Pennsylvania Technical Advisory Committee On Diesel Powered Equipment

January 7, 2008

Recommendation for FINAL approval of a Brookville Equipment Corporation Brookville Model 20T193D 20 Ton Locomotive with a Cummins QSB 6.7 193HP diesel engine and a M30 DST Filter (M267 Total System).

ATTACHMENT Z

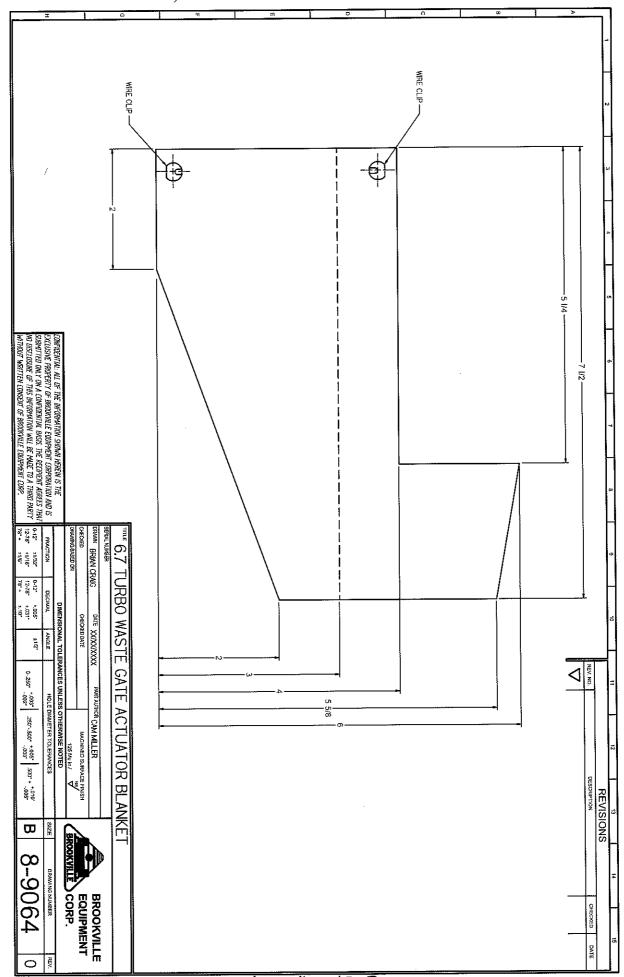
Brookville obtained measurements and agreed to manufacture a more permanent wrap made out of the same "Fire Wrap" material to replace the temporary wrap installed that day. A drawing of the permanent wrap is provided in Attachment 2.

- The temporary "Fire Wrap" material wrap on the turbo arm bracket should be replaced with the permanent "Fire Wrap" part (as shown in Attachment 2) on the first 100 hour maintenance performed after the part is delivered. The installation of the permanent wrap shall be noted in the 100 hour maintenance record when it is installed. The BMS should be notified when this permanent part is installed.
- This recommendation is provided with the understanding that the General Specification Sheet (Attachment 1-Rev) be strictly adhered to. As stated in the September 6, 2007 recommendation to the director, we are also recommending FINAL approval of an alternate test procedure for Sections 217-A and 218-A of the act (Attachment 3).
